SP13-41: GAS SPRING INTERFERENCE WITH PANTOGRAPH ARM - X SERIES LUGGAGE DOOR  
REFER TO SAP FOR CODES AND VEHICLES  
VEUILLEZ VOUS RÉFÉRER AU RETROFIT R13047

### FOR ALL LUGGAGE DOORS WITH PANTOGRAPH MECHANISM ON VEHICLE

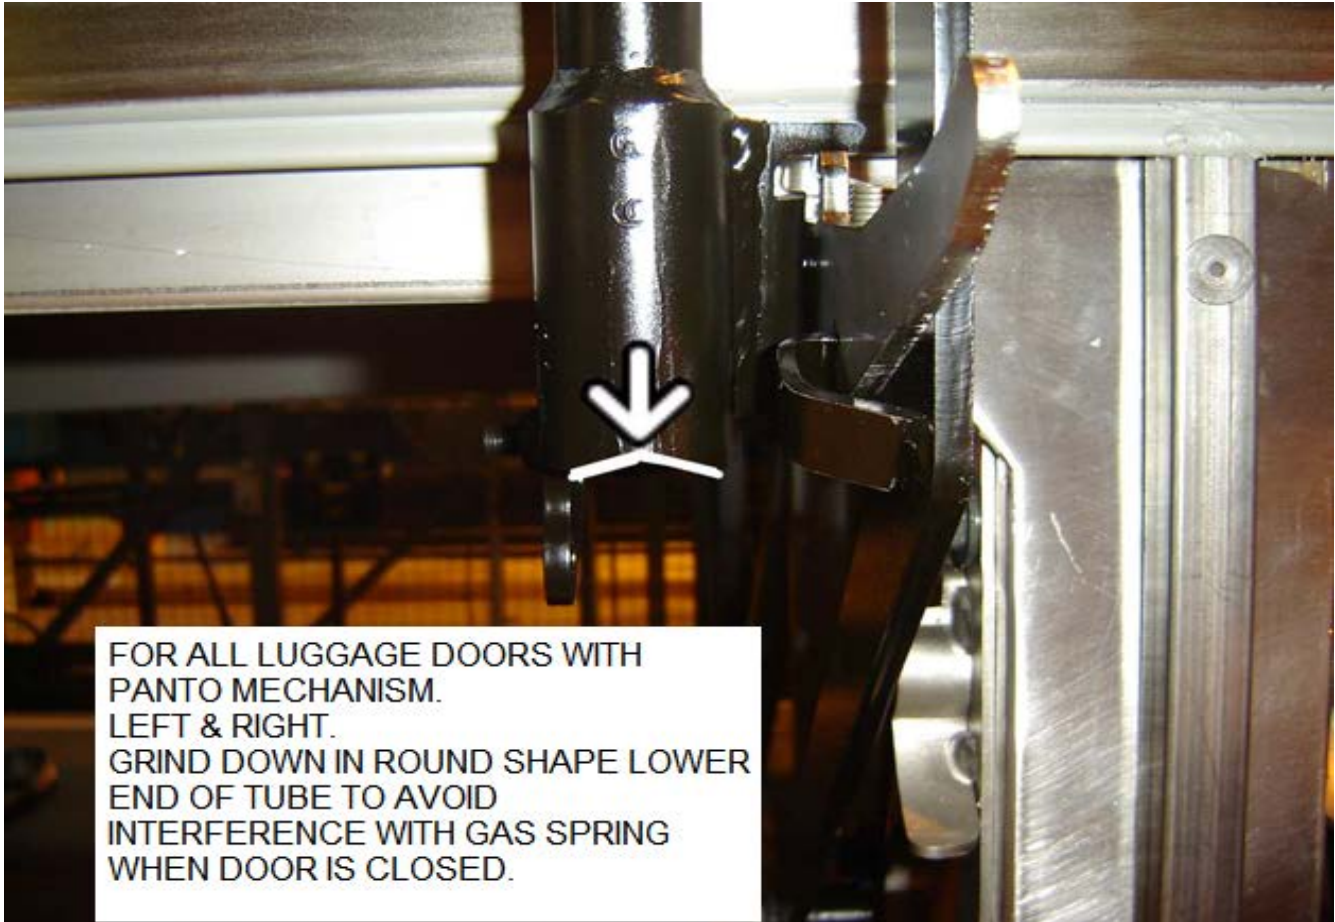
CHECK THAT THE PANTO ARM DOES NOT INTERFERE WITH GAS SPRING IN "DOOR CLOSED" POSITION.

### INSPECT LEFT & RIGHT ARMS

TOTAL: 12 ENDS TO INSPECT.

IF REQUIRED, GRIND THE END AND PAINT WITH **683964**

PROTECT & MASK SURROUNDING AREA TO AVOID PAINT PROJECTION & MIST

FOR ALL LUGGAGE DOORS WITH  
PANTO MECHANISM.  
LEFT & RIGHT.  
GRIND DOWN IN ROUND SHAPE LOWER  
END OF TUBE TO AVOID  
INTERFERENCE WITH GAS SPRING  
WHEN DOOR IS CLOSED.
